Synchronizer Assembly Fastener Change — T200 and T300 Transmissions

M-431-001

(April 2008)

Synchronizer Assembly Fastener — T200 and T300 Transmissions

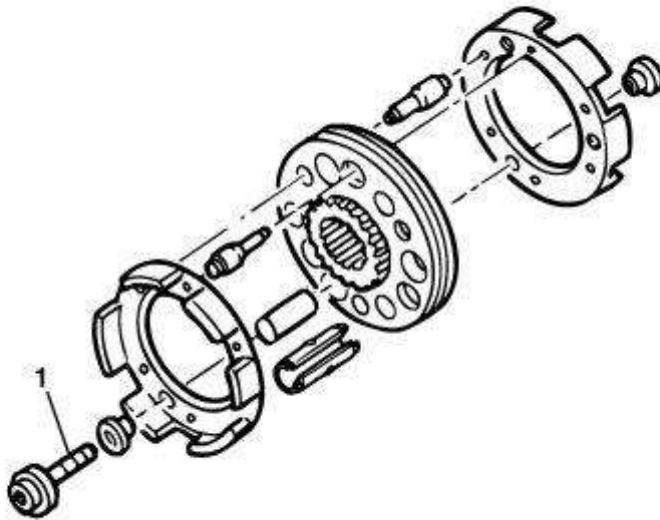
Effective November 28, 2007, a revised fastener (part number 551KC216) was implemented into production on the synchronizer assembly used in MACK T200 and T300 transmissions. This revised fastener incorporates Scotch-Grip™ adhesive, replacing the patch-lock type fastener, which was used previously. Should the synchronizer assembly be disassembled for any reason, it is recommended that these revised fasteners be used at reassembly. Tightening torque specification remains the same.

Key	Qty.	Part number	Description	Replaces
1	3	551KC216/ 21158575	Bolt with Scotch-Grip™ adhesive	25107877/ 6AX1606X/ 6AX1582

Note: These fasteners are one-time use fasteners only. They must be replaced anytime the synchronizer assembly is disassembled.
